REGULATORY INFORMATION DISTRIBUTION SYSTEM (RIDS)
DISTRIBUTION FOR INCOMING MATERIAL TOPREP

SUBJECT:
FORWARDING RESPONSES TO LTR "MARK II STP INFO REQUEST" WITH ATT, REQUEST FOR ADDL INFO" - MARK II CONTAINMENT POOL DYNAMIC LOADS", DTD 04/18/78.

SUBJECT: RESPONSES TO NRC REQUEST FOR ADDITIONAL INFORMATION (ROUND 3 QUESTIONS)

Reference: Letter "Mark II STP Information Request" with attachment, "Request for Additional Information" - Mark II Containment Pool Dynamic Loads" to I. Peltier (NRC -DPM) from C. Anderson (NRC - DSS), dated April 18, 1978

FIG 3

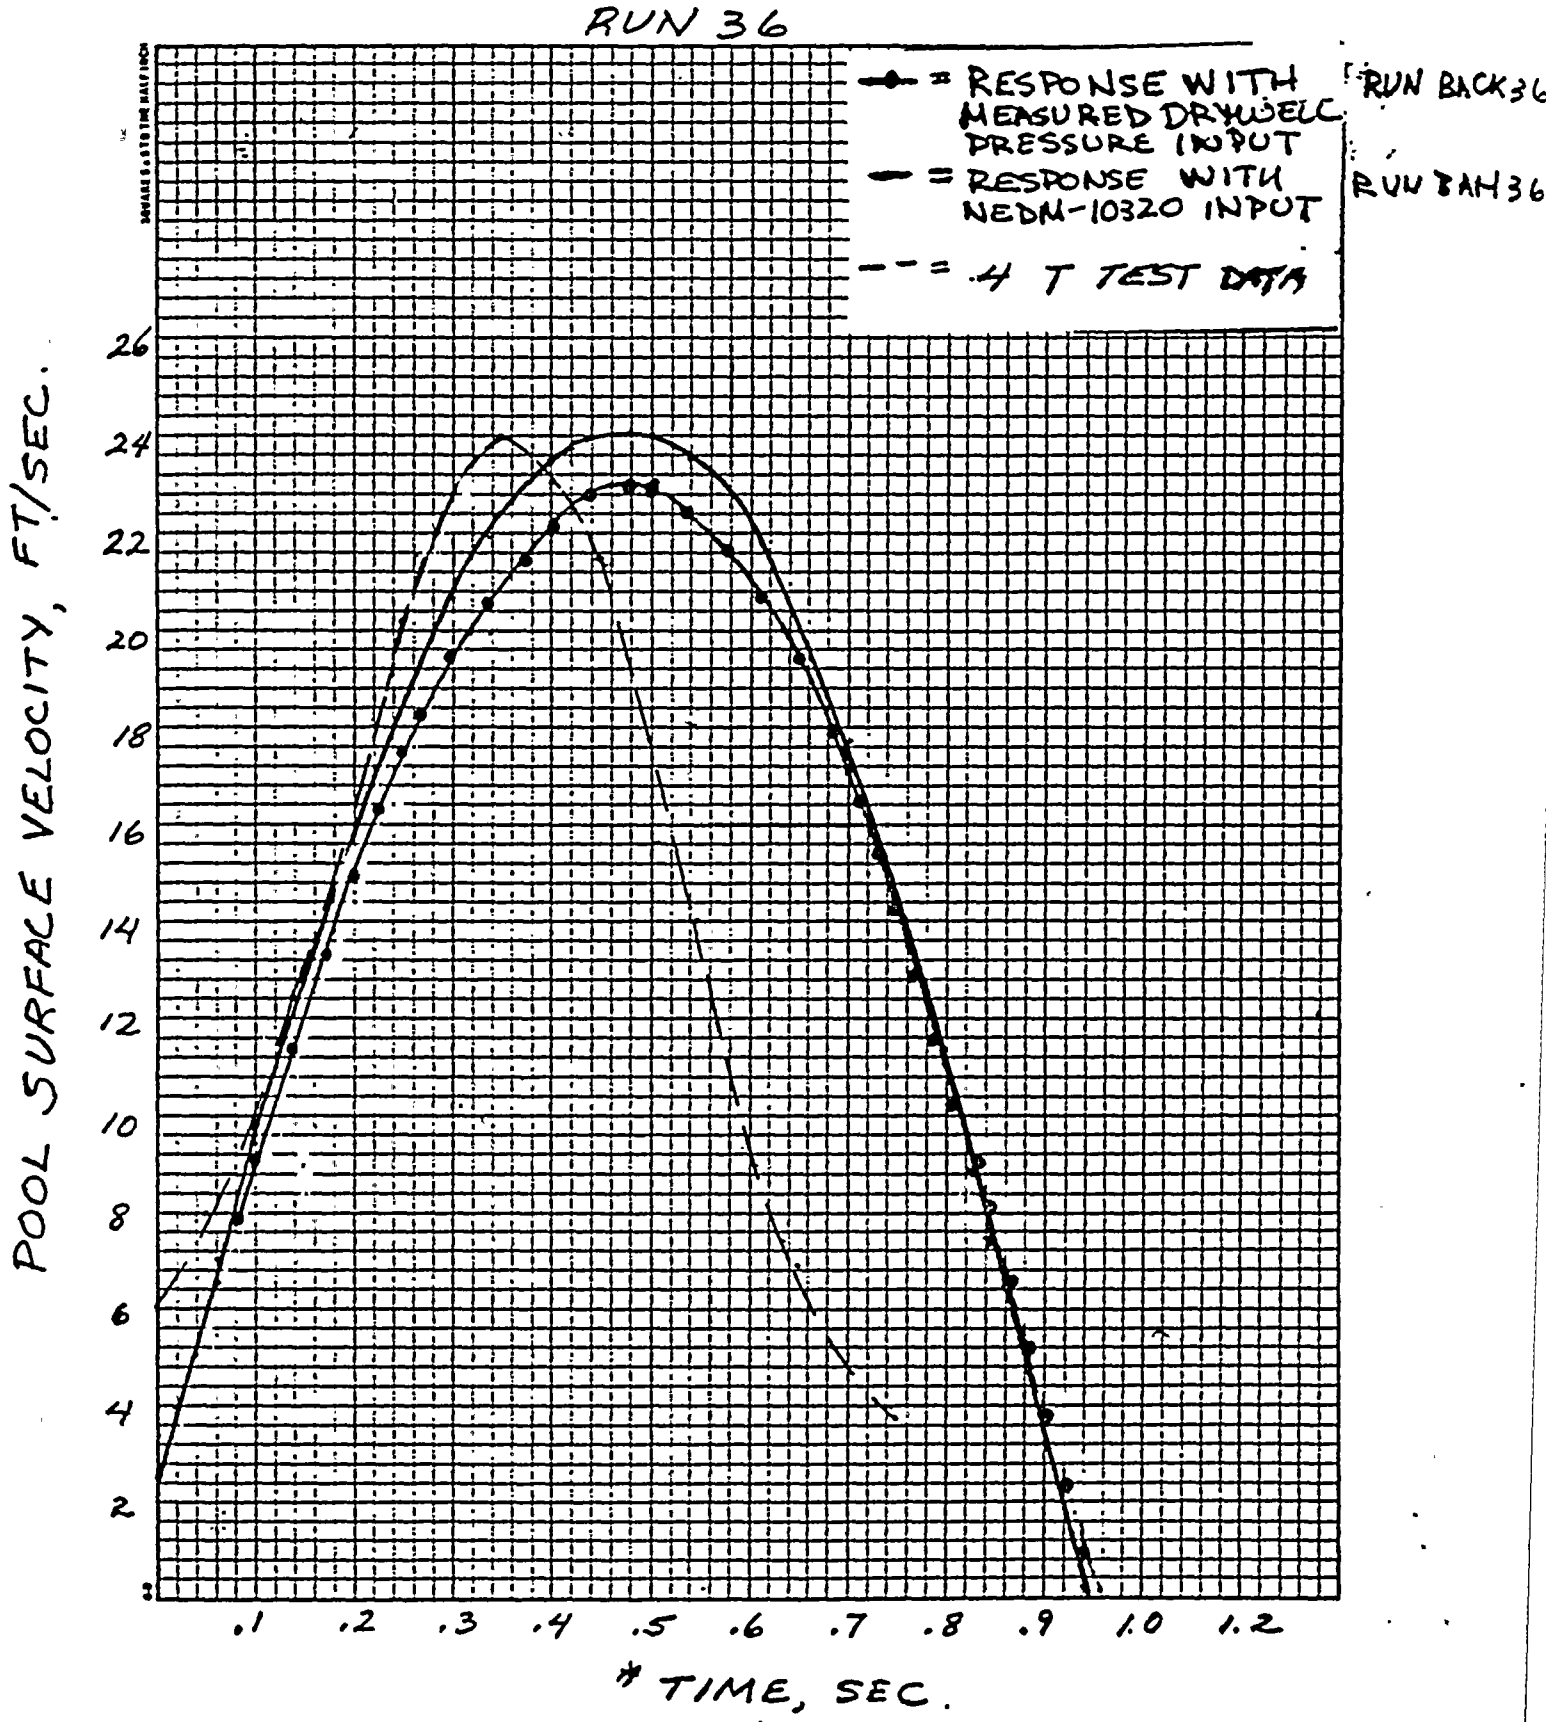
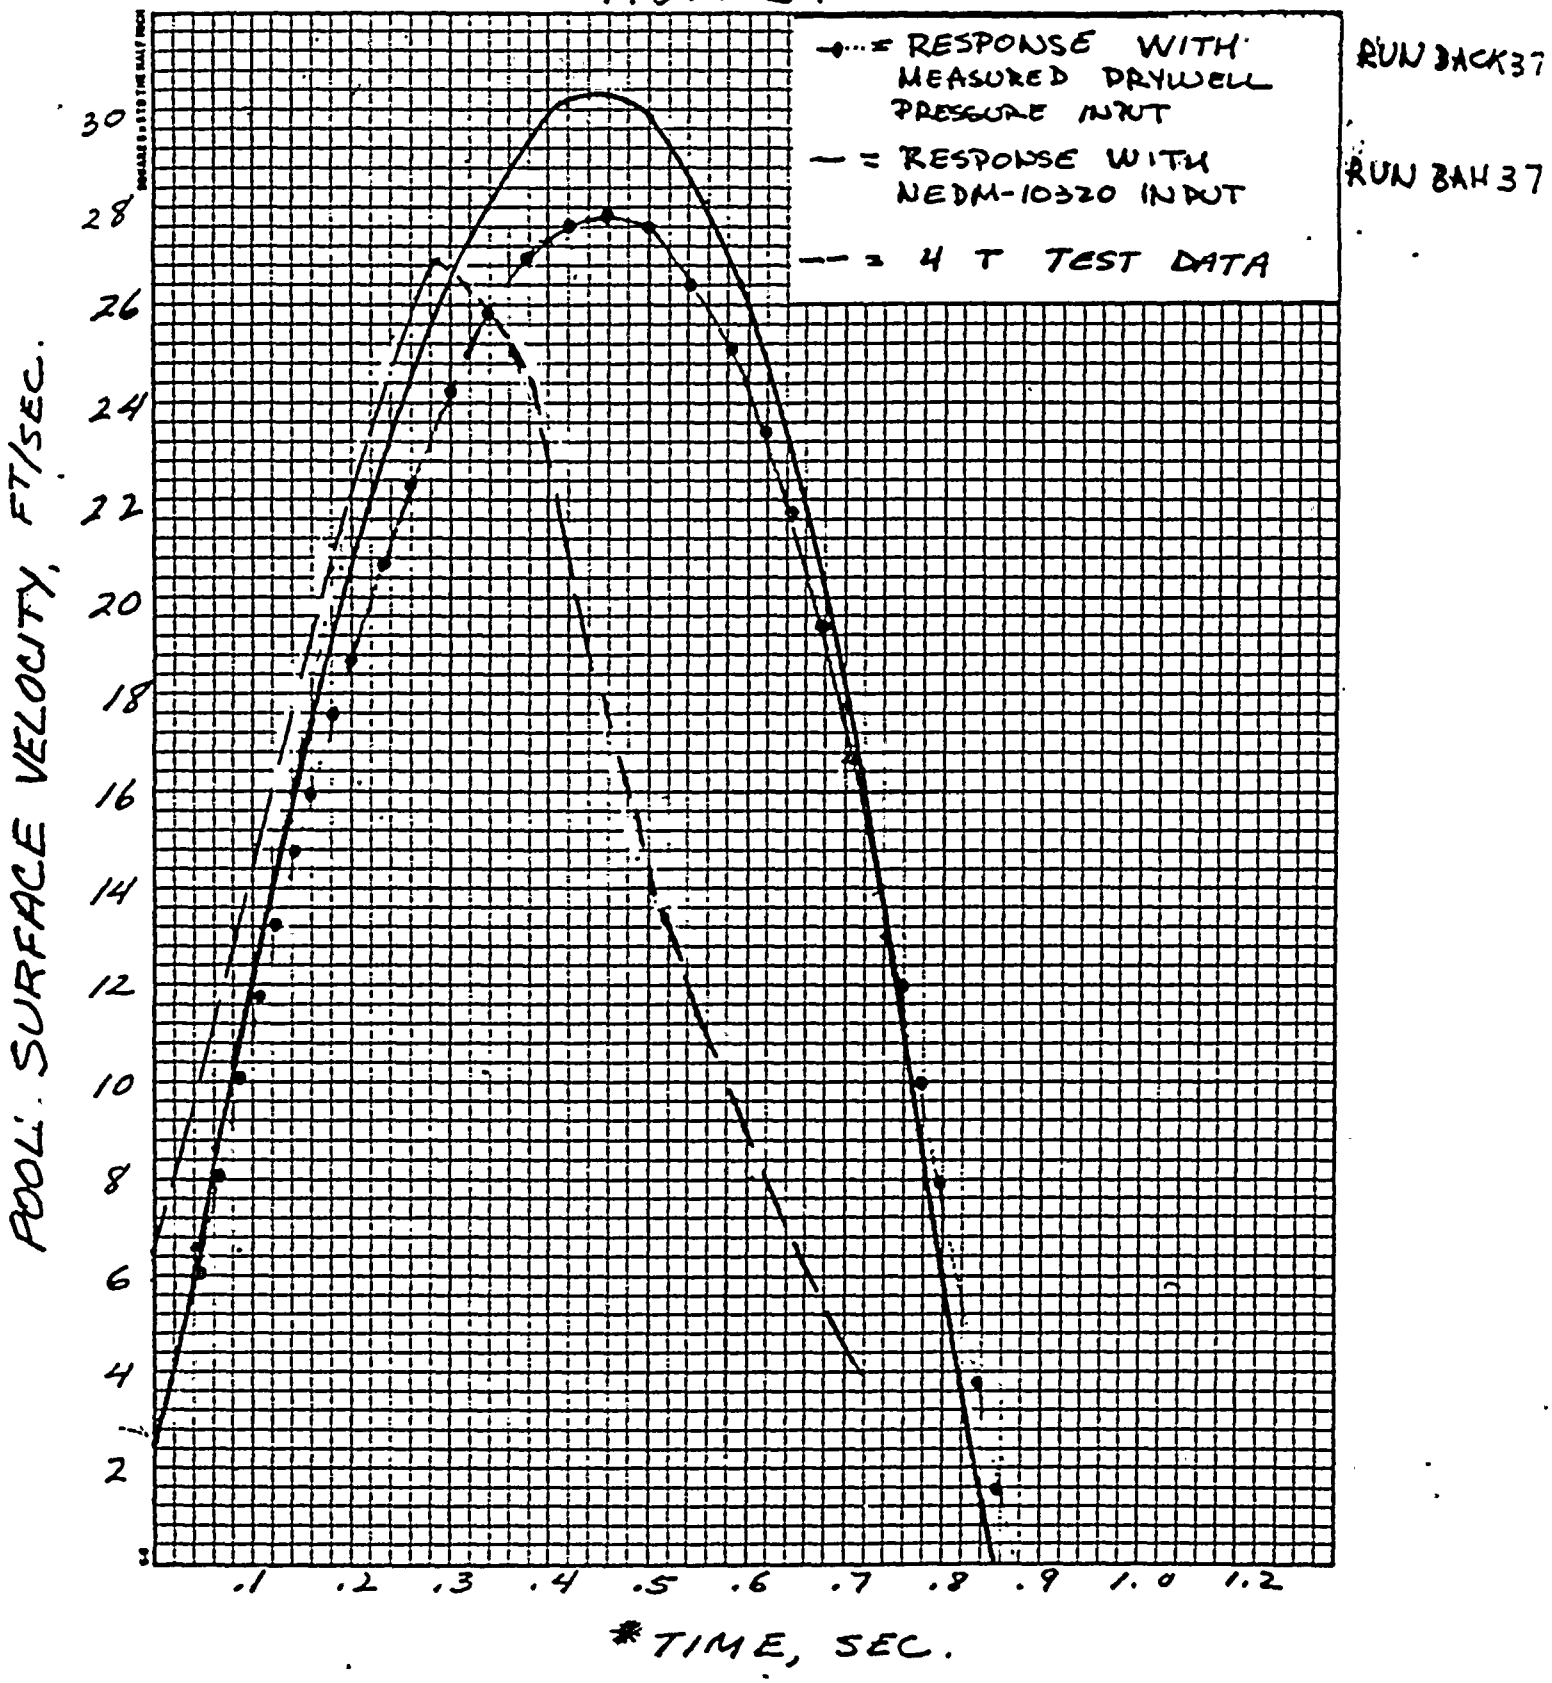
In the response to NRC questions M020.58(4) (NRC questions dated January 14, 1977) it is stated that "Calculations of pool swell for Mark II containments using the analytical model utilize the appropriate calculated drywell pressure response (NEDM-10320) as an input." It is our position that the specification of pressure history is an essential element of the DFFR methodology and that the particular choice cited above has not been demonstrated to be appropriate.

To justify such use, we require that pool swell calculations be made for selected 4T tests using drywell pressure response computed according to NEDM-10320 in lieu of the measured drywell pressure histories. The selected 4T tests are the two saturated liquid blowdowns made during the phase II test series (Runs 36 and 37). The response (pool swell elevation, velocity, bubble pressure) calculated in this manner should be compared with measured values and with similar calculations made using the measured drywell pressure histories.

The pool surface velocity (Figures 3 and 4) curves illustrate that the maximum velocities calculated using NEDM-10320 pressures are greater (as in run 37) or comparable (as in run 36) to those measured in the 4T tests. Additionally, pool surface velocities using NEDM-10320 input consistently exceed the velocities calculated using the 4T measured drywell pressures.
